UNITED STATES PATENT AND TRADEMARK OFFICE

10/758,925

Office Action Summary

DETAILED ACTION

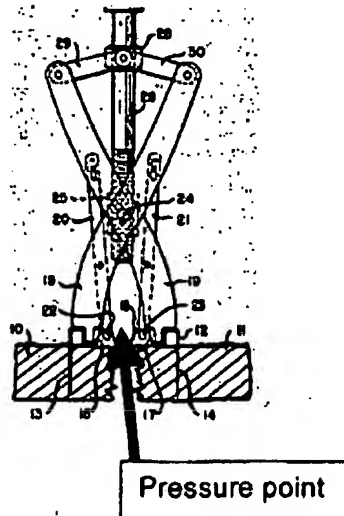
Murray discloses pliers capable of adjusting a bone plate having two jaws (18/19) that move relative to one another and at least two spaced apart pin members (16/17) that are axially extended to be inserted into bone plates. The pin members have a

variable outer diameter, similar to a peg-like shape (see Figs. 3-6, both A and B), and also have a portion that is considered a pressure-exerting element (see drawing below) that creates pressure as the device is used and actuated in squeezing the bone plate.

Applicant's arguments filed 3/26/2007 have been fully considered but they are not persuasive. As noted above the pin members as amended from receptacles still read on the cited art of record as protruding members that fit into the substantially planar plate. When in use the device would provide a pressure-exerting area and element (this is the area denoted by the arrow as the portion approximately adjacent to item 15 in Figure. 3).
